Re: Ferrari North America: Defect Information Report

DEFECT INFORMATION REPORT

U.S.A. RECALL CAMPAIGN No. 47

Replacement of the Clutch Sensor in the F1 Transmission.

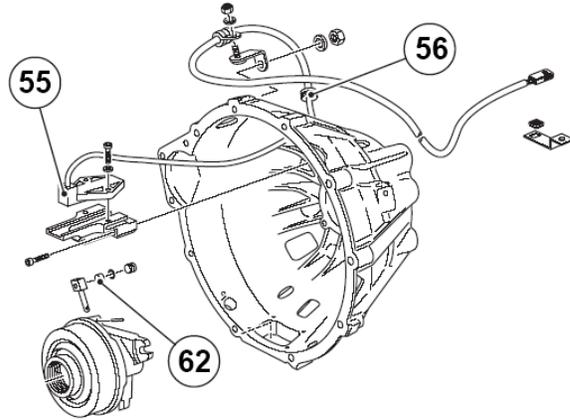
Replacement of the clutch sensor - Part No.: **182311**- with the **new F1 clutch sensor Kit Part No.: 70001323** (244801 with standard connector), Fig. 1.

Replacement of the clutch sensor - Part No.: **206075**- with the **new F1 clutch sensor Kit Part No.: 70001324** (243784 with waterproof connector), Fig. 2.

- › **Complete clutch sensor kit, F1 gearbox, Part no. 244801 (with standard connector);**
- › **Complete clutch sensor kit, F1 gearbox, Part no. 243784 (with waterproof connector);**

- Ref. 55 Sensor
- Ref. 56 Cable holder
- Ref. 62 Magnet

I. Replace the F1 clutch sensor (as described in chapter D3.01 of the Workshop Manual), fitting the new one in relation to the different vehicle groups as indicated on page 1.

II. Connect the SD3 tester to the vehicle diagnostic socket and perform the following operations:

II a) - Bleed the electronically-controlled gearbox clutch system (as described in chapter D3.04 of the Workshop Manual).

II b) - Access the ACTIVE DIAGNOSIS environment and run a “SELF-LEARNING” cycle.

II c) - Access the ERROR environment and “DELETE THE ERRORS”, then disconnect the SD3 tester.

III. Road-test the vehicle (“free drive test”) for approximately 10 minutes, in order to ensure that the vehicle functions properly.
